**SUSQUEHANNA STEAM ELECTRIC STATION  
RESPONSE TO REQUEST FOR ADDITIONAL  
INFORMATION ON AMENDMENT REQUEST  
NO. 299 FOR OPERATING LICENSE NO. NPF-14  
AND AMENDMENT REQUEST FOR OPERATING  
LICENSE NO. NPF-22: PRA QUESTIONS  
PLA-6473**

**Docket Nos. 50-387  
and 50-388**

**ATTACHMENT 1 TO PLA-6473**

**RESPONSES TO REQUESTS FOR ADDITIONAL  
INFORMATION**

### Unit 1 LERF (HE) Contribution By Sequence

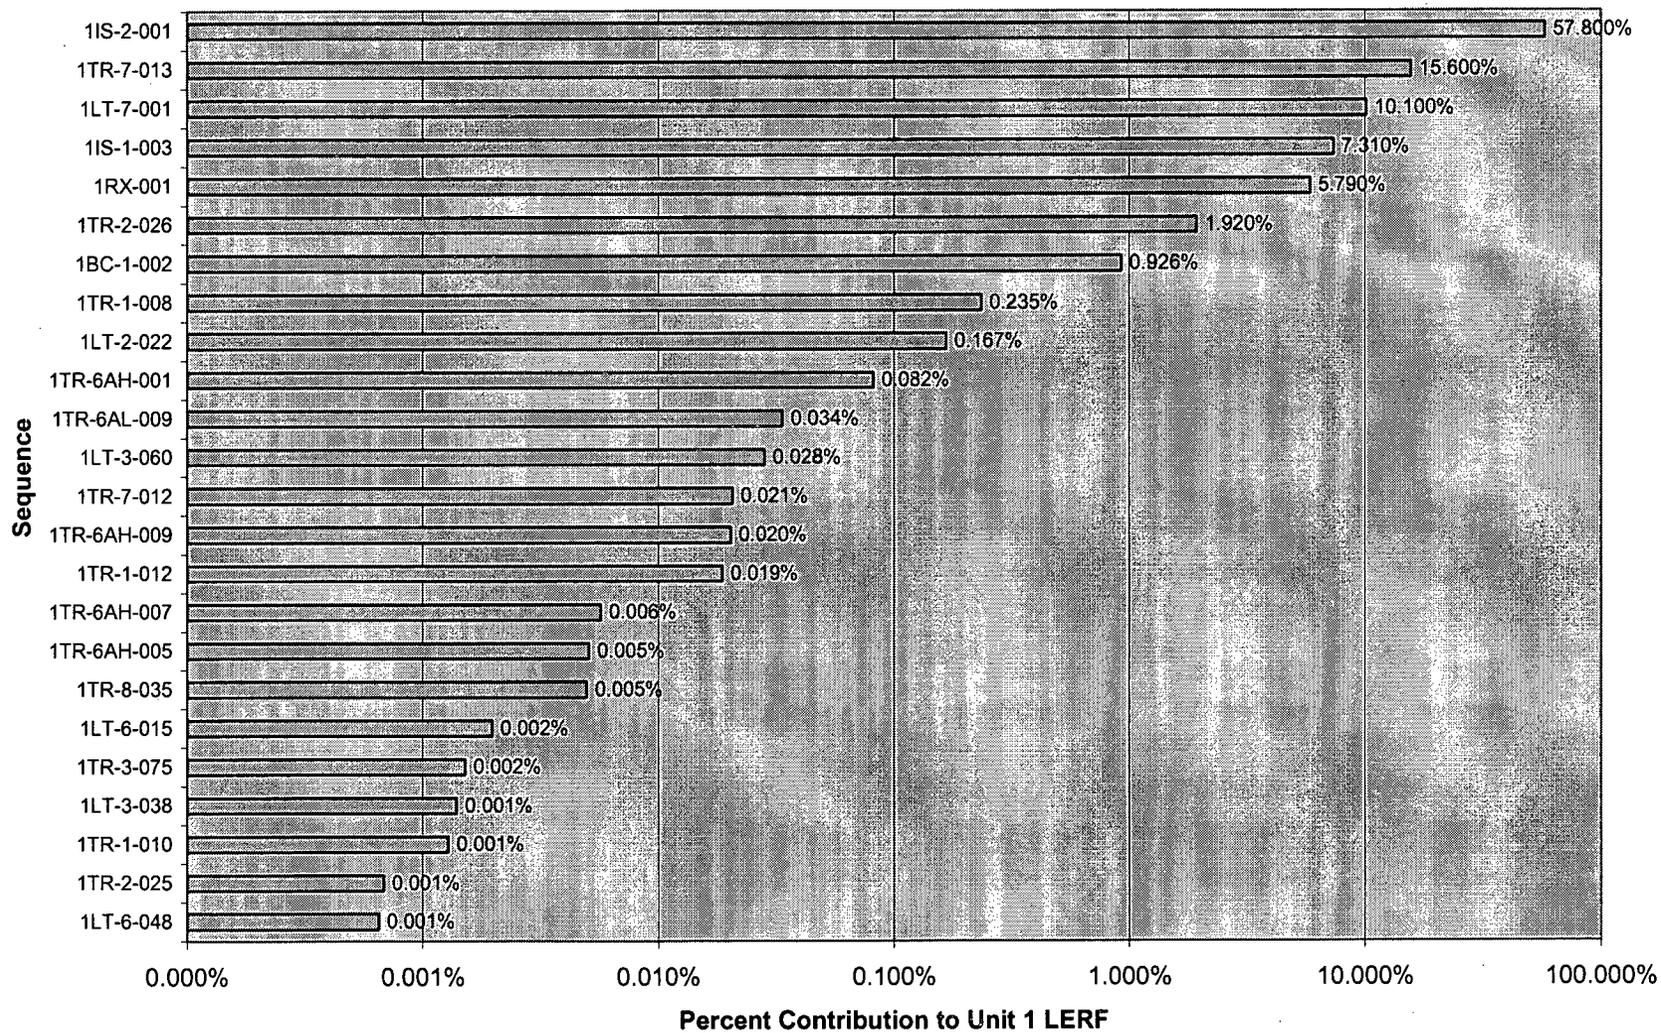
It is stated in Section 4.4.2 that the majority of postulated containment failures involve catastrophic containment over-pressure failures, which are also predicted to fail secondary containment, thereby rendering SGTS ineffective. Explain why use of the containment vent in accordance with SSES's plant-specific implementation of the BWROG Emergency Procedure and Severe Accident Guidelines (EP/SAGs) is not effective in reducing the overall contribution from containment over-pressure failures. The explanation may take the form of discussing the top LERF sequences and why venting does not reduce the containment failures. (The generic EP/SAGs direct containment venting irrespective of dose in order to prevent containment failure.) If this statement is the result of the SSES PRA treating containment venting in a different manner than directed in the plant-specific EP/SAGs, provide a re-characterization of: (1) severe accident containment response/failure assuming appropriate credit for containment venting (i.e., operator actions consistent with the plant-specific EP/SAGs), and (2) the effectiveness of SGTS in reducing severe accident releases/risk assuming appropriate credit for containment venting.

Given core damage has occurred, venting or not venting primary containment does very little to the Large Early Release Frequency (LERF). As seen from the bar graph and table below, 99.4% of the LERF is unaffected by primary containment venting.

The use of the primary containment vent in accordance with SSES's plant specific procedures is effective in reducing primary containment over-pressure failures. Venting of the primary containment will result in the failure of secondary containment due to the large amount of gas released. Failing secondary containment renders SGTS ineffective. Therefore, the end result is the same; when the primary containment is either failed or vented, secondary containment will fail which renders SGTS ineffective.

**Cumulative Top 99.4% of LERF by Sequence**
